**DATE:** 07.17.2019  
**TO:** ProTrak  
**FROM:** Mitesh Baxi  
Traffic Engineering

■ **SECU S 17TH STREET [TRC Plan Review]**

↻ Initial Review Note ↻

### SECU S 17th Street Standard Street Lighting Plan

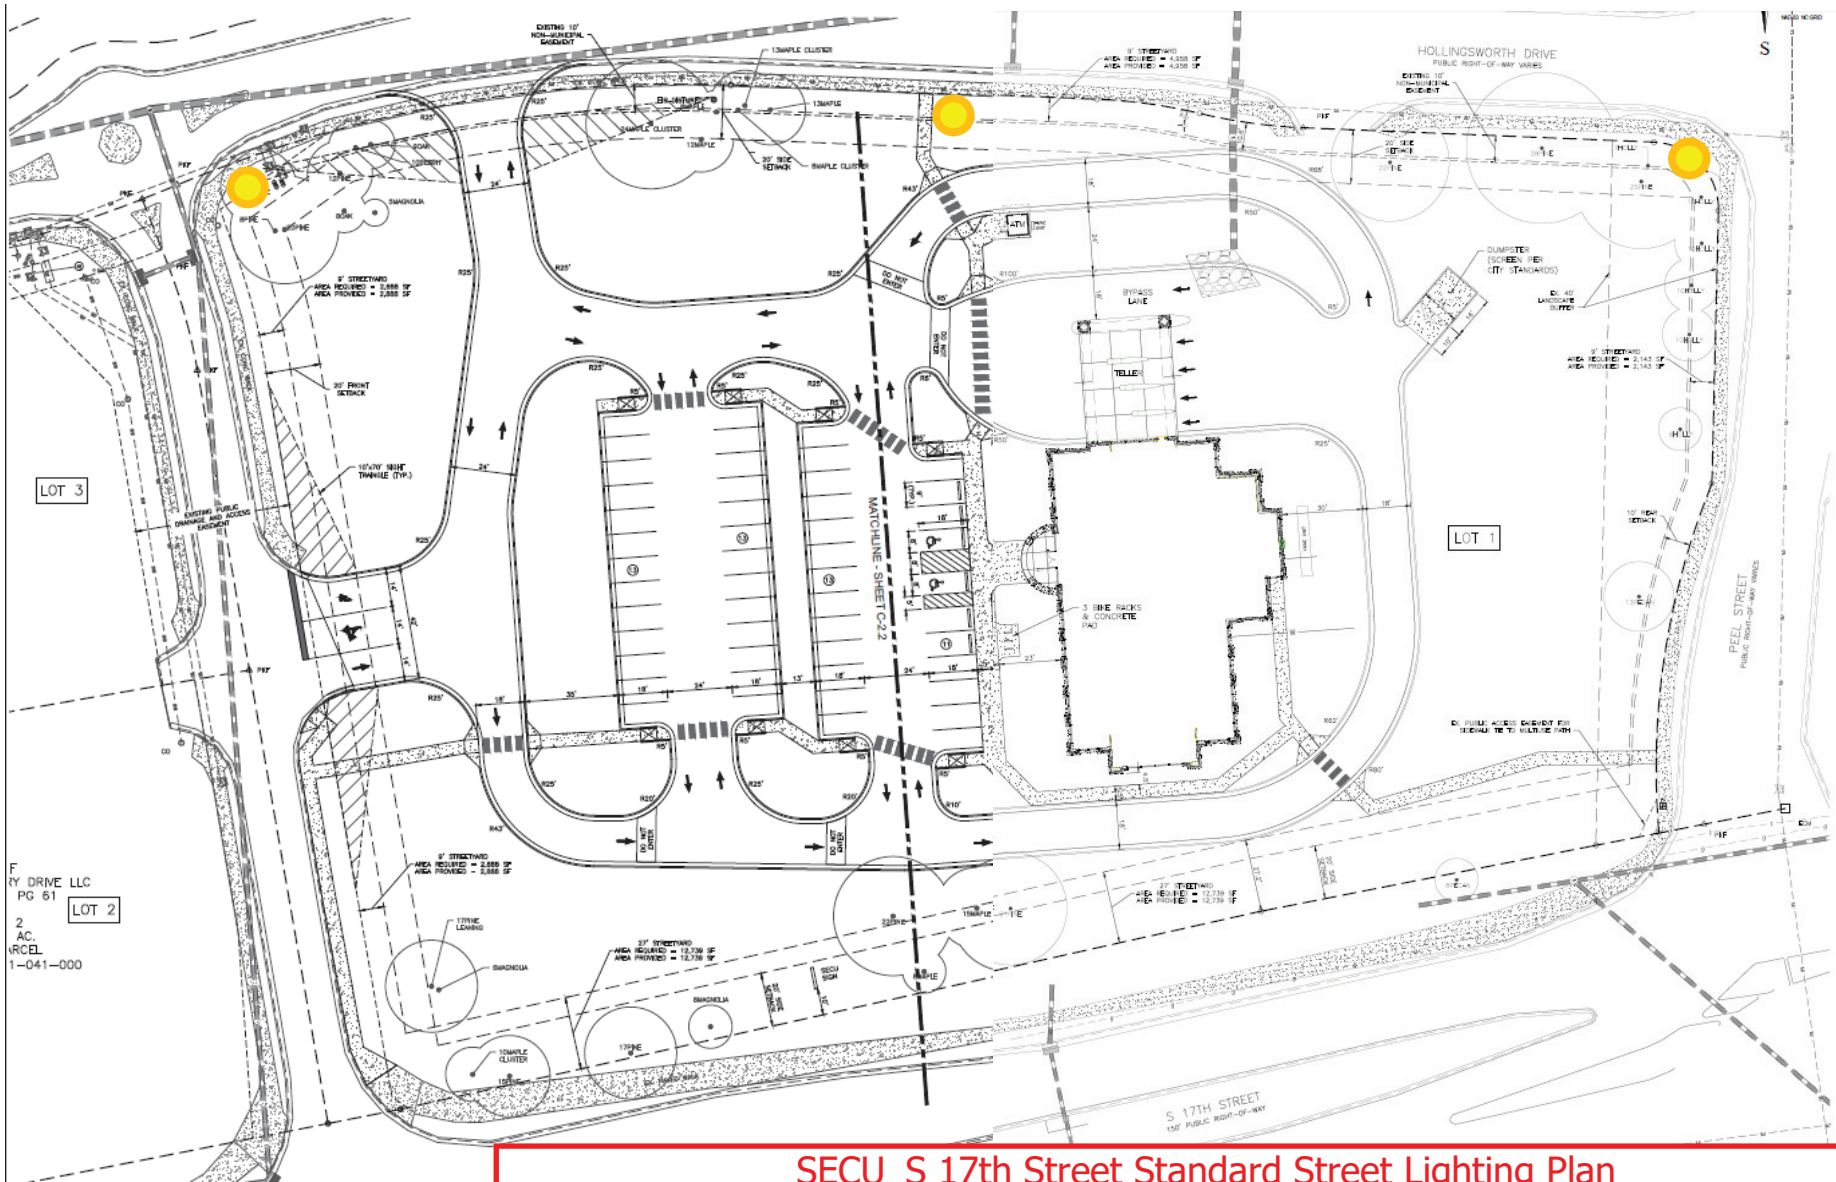
2. A layout for the Standard street lighting has been provided with the review. Minimum of 3 LED 50s are required for this sub-division. Subject to change based on the study by DEP.

1. Developers shall bear any installation costs associated with streetlights, if applicable. In areas served from underground facilities, the developers shall pay the one-time underground contribution charge, if applicable.
  2. Streetlights will be reviewed through the subdivision process and must meet criteria established in City's Street Lighting Policy.
  3. All the street lights shall be installed within the public ROW.
  4. Street trees must be located a minimum of 15' from street lights [SD 15-17 of CofWTSSM].
- Suggested approximate locations of minimum required 3 LED 50.  
This layout is subject to change based on the study by DEP.
